# Work Order ID 119542

Item Name: Fwd Crosstube - High

DRAWING NO. D212-664-141	TITLE XTUBE ASSY (205/212/412 HI FWD)	REV. D	DART AEROSPACE LTD ENGINEERING ORDER		D.E.O. NO. D212-664-141-D-1	SHEET NO. SHEET 1 OF 2	SCALE NTS
DRAWN	CHECKED	UP	MFG. APPR.	APPROVED	DE APPR.		
DATE 11.04.07	DATE 11.07.11		DATE 11.04.12	DATE 11/04/12	DATE 11.04.12

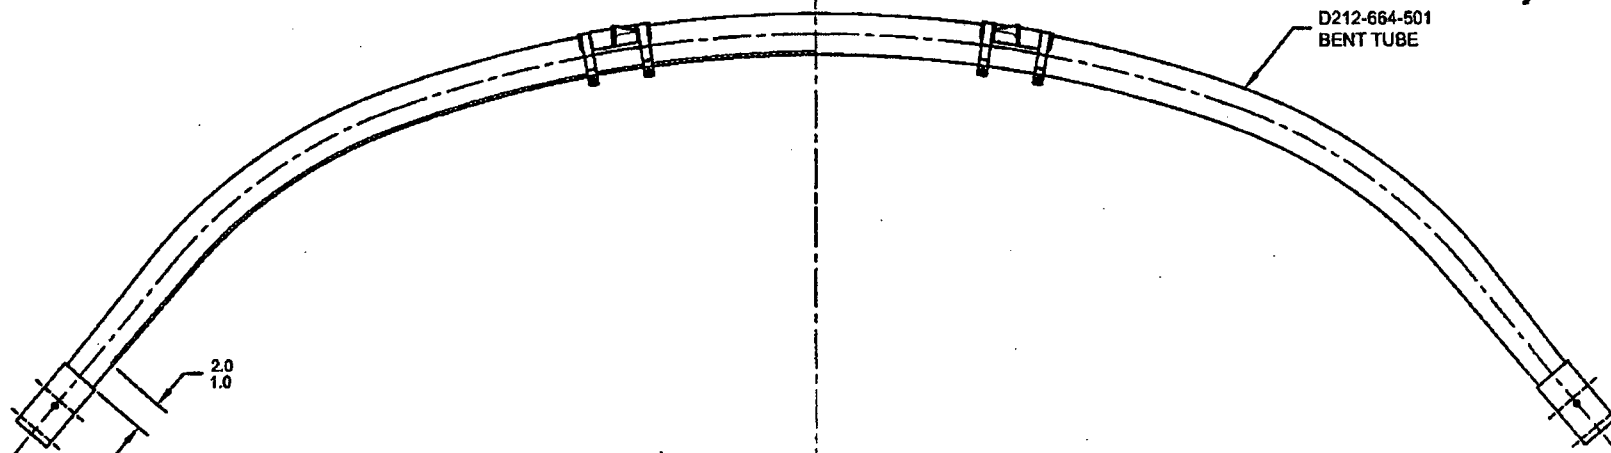
**PURPOSE:**

ADD AN INSPECTION WINDOW TO UNDERSIDE OF CROSSTUBE.

NOTES 2 OF SHEET 1 IS AMENDED AS FOLLOWS:

- 2) FINISH: CHEMICAL CONVERSION COAT PER DART QSI 005 4.1  
PRIME INSIDE AND OUTSIDE PER DART QSI 005 4.2  
MASK UNDERSIDE OF CROSSTUBE AS SHOWN (HATCHED AREA) AND  
PAINT OUTSIDE PER DART QSI 005 4.2  
REMOVE MASKING AND APPLY CLEAR COAT

MASK AREA PRIOR TO PAINTING.  
REMOVE MASKING AFTER PAINT  
AND APPLY CLEAR COAT
